Addendum No. 1 **March 23, 2023**

City Project No.: 22-001
Citywide Street Rehabilitation and Improvement Project Package 1

This addendum includes revisions to Plans and Specifications and provides clarifications and answers to questions submitted to the City.

DRAWING No. L-06
SHEET: 17 OF 169

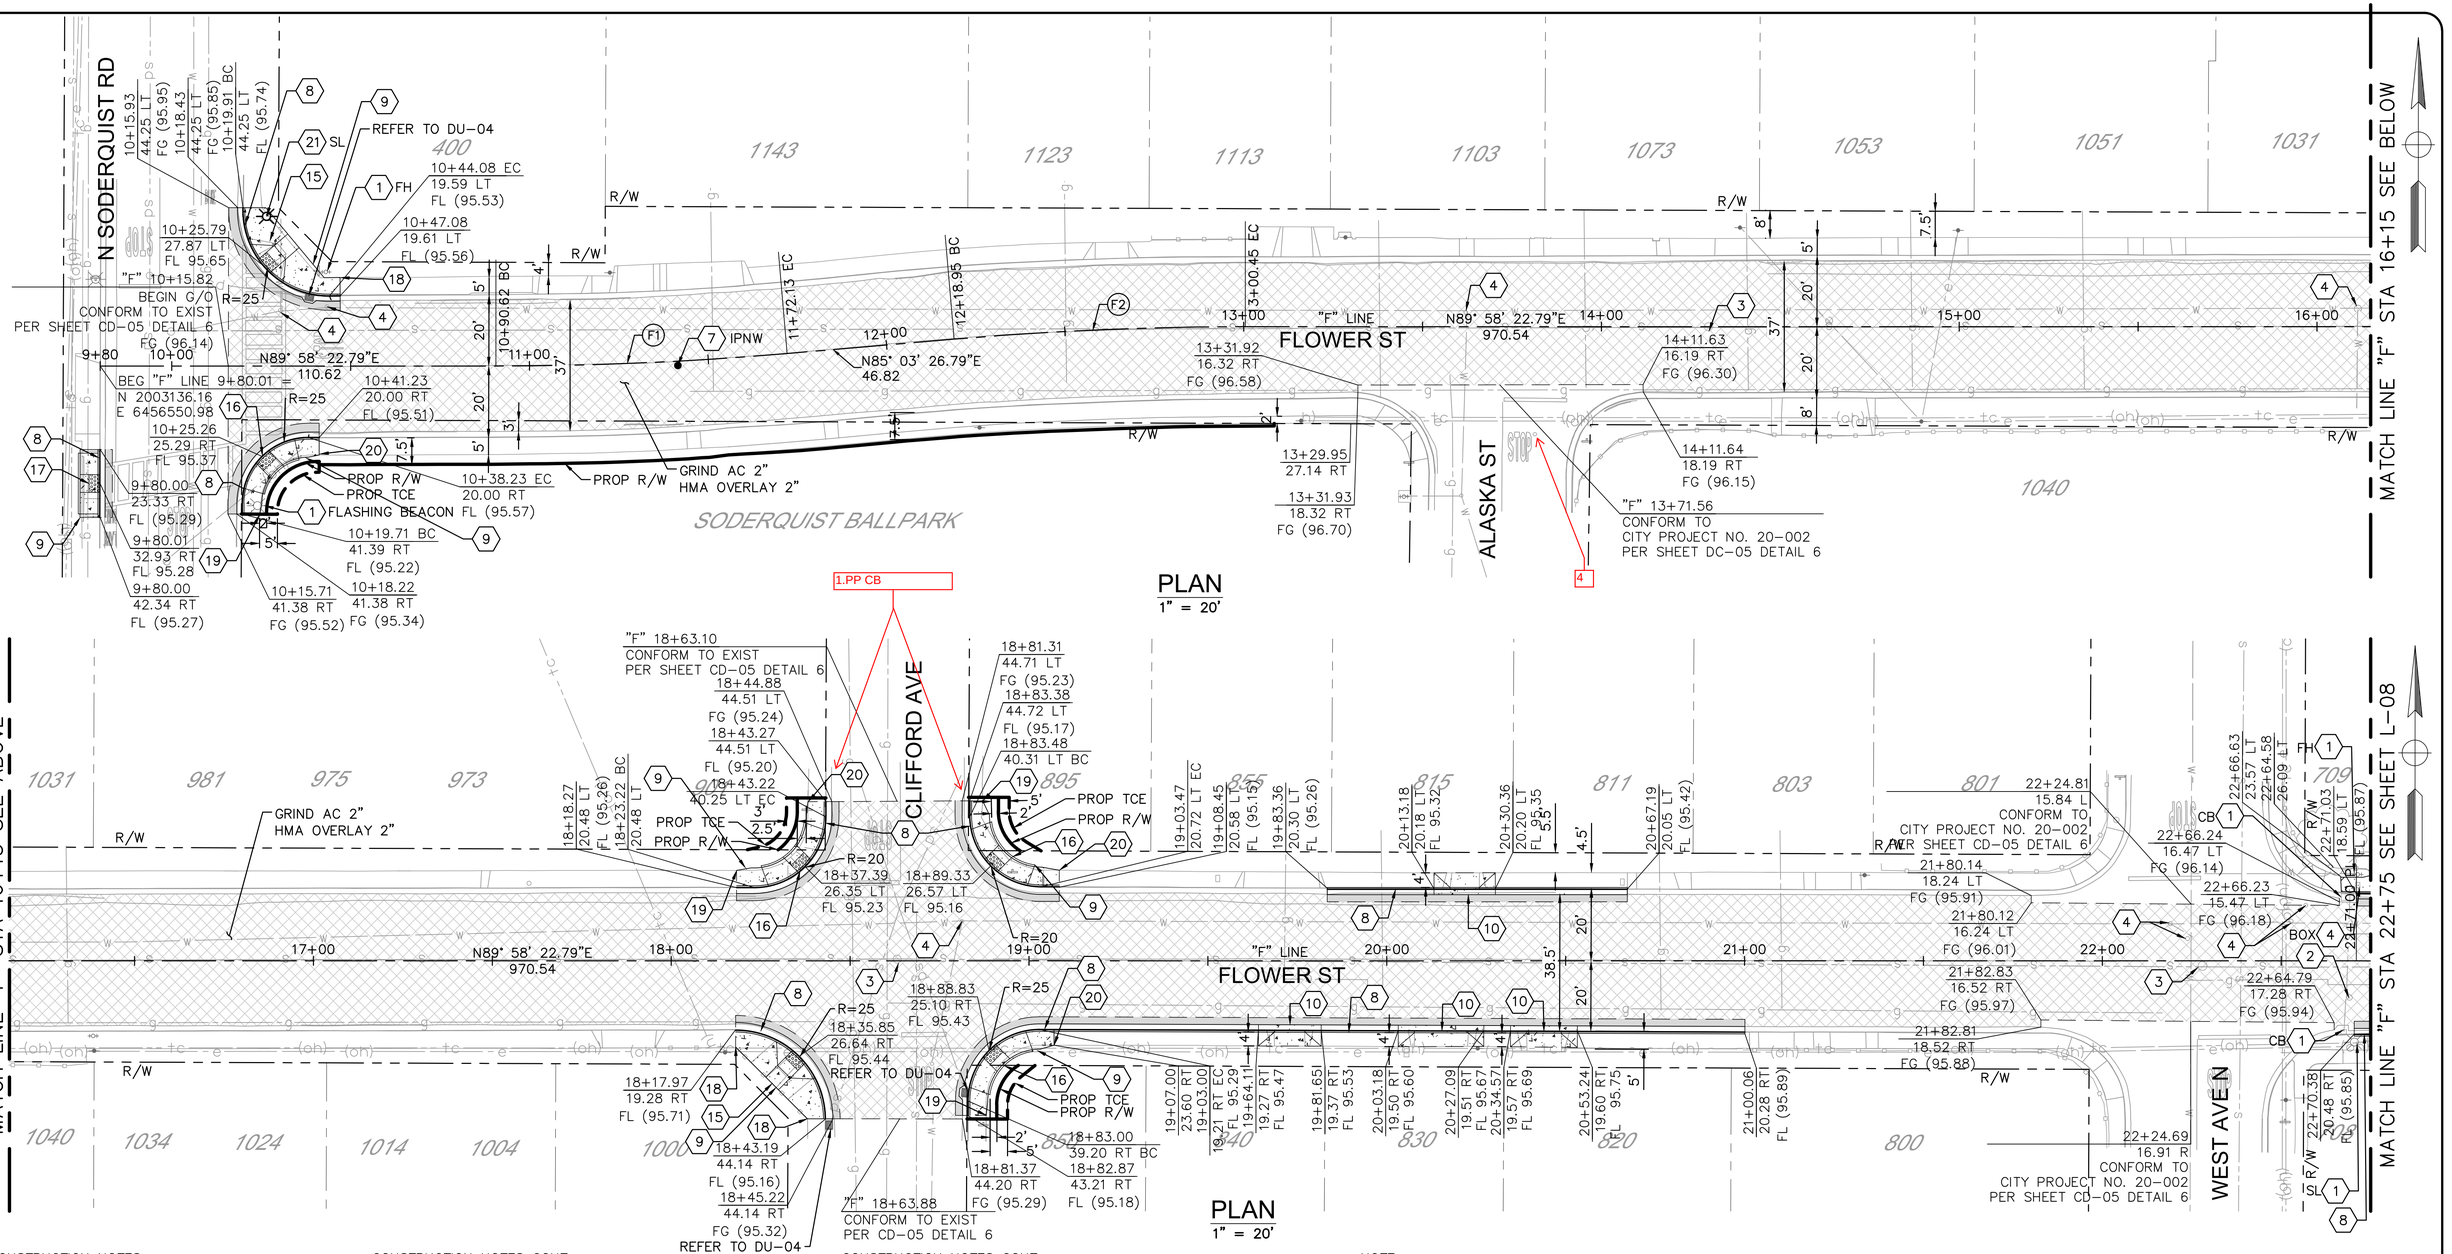
Location	Station	Drawing
Park Street		
617 Park Street	28+50L	L-05
617 Park Street	28+80L	L-05
434 N. Broadway (Intersection of Park St. & Lexington Ave.)	100+15R	L-06
Flower Street		
390 Flower Street (Intersection of Flower St. & N. Orange St.)	38+25R	L-09
390 Flower Street	38+45R	L-09
374 Flower Street	38+75R	L-09
338 N. Broadway (Intersection of Flower St. & Lexington Ave.)	41+20R	L-09
338 N. Broadway (Intersection of Flower St. & Lexington Ave.)	41+30R	L-09
338 N. Broadway (Intersection of Flower St. & N. Broadway)	42+75R	L-09
N. Orange Street		
403 W. Main Street (Two small trees behind sidewalk)	10+50	L-12
403 W. Main Street	11+25L	L-12
123 N. Orange Street	12+25L	L-12
Locust Street		
318 Locust Street	17+10R	L-13
318 Locust Street	17+25R	L-13

DRAWING No. SS-06
SHEET: 111 OF 169

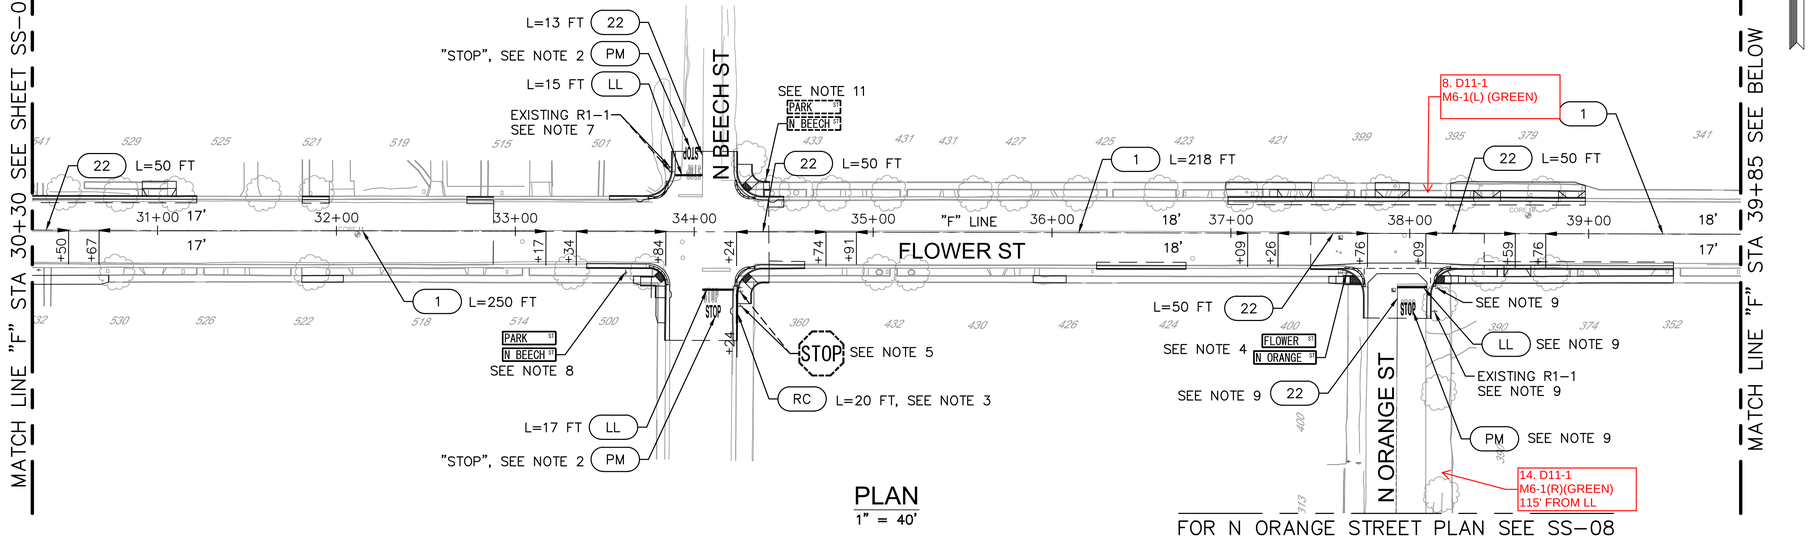
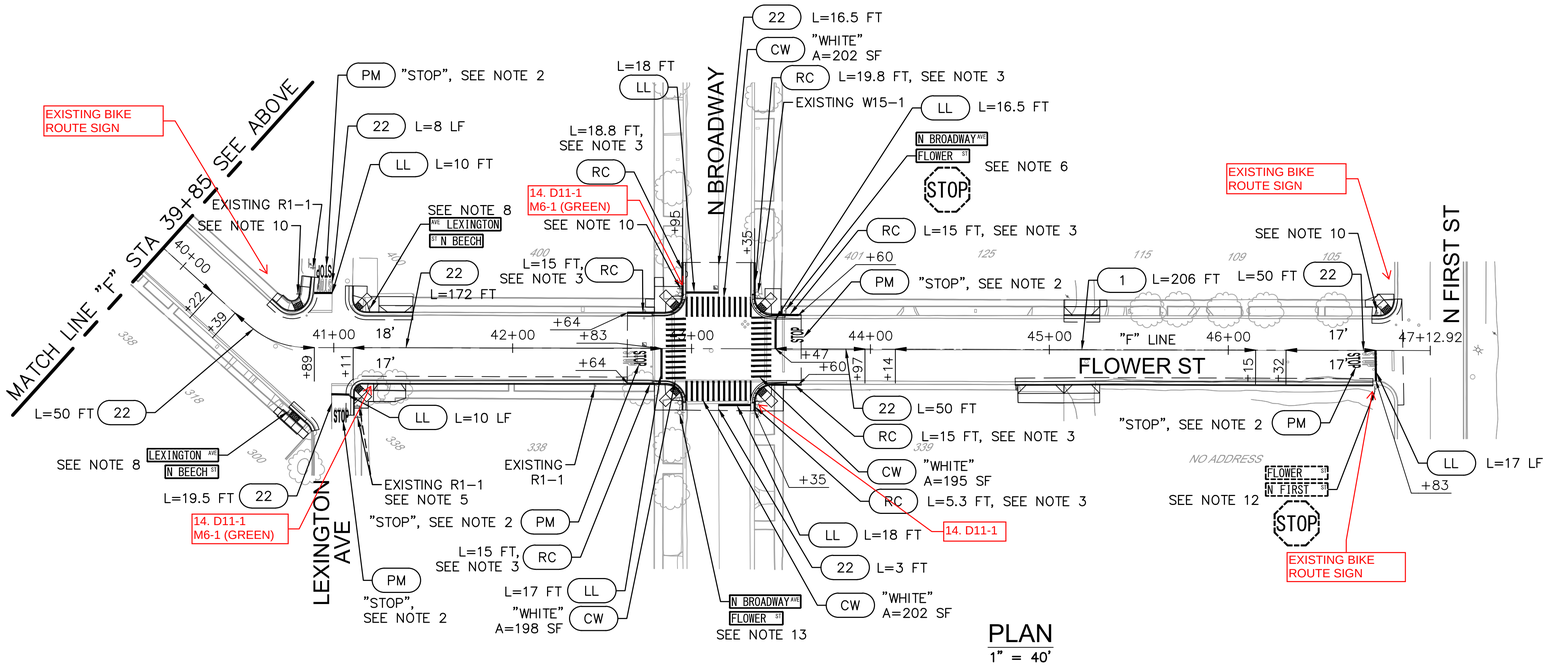
Plan sheets L-01 through L-34, DU-08, TD-19, SS-06, SS-12, and CD-05 shall be modified as noted on the attached sheets L-01 through L-34, DU-08, TD-19, SS-06, SS-12, CD-05 and the detail sheets that follow, C2 through C4, D1 through D9, and EX1.
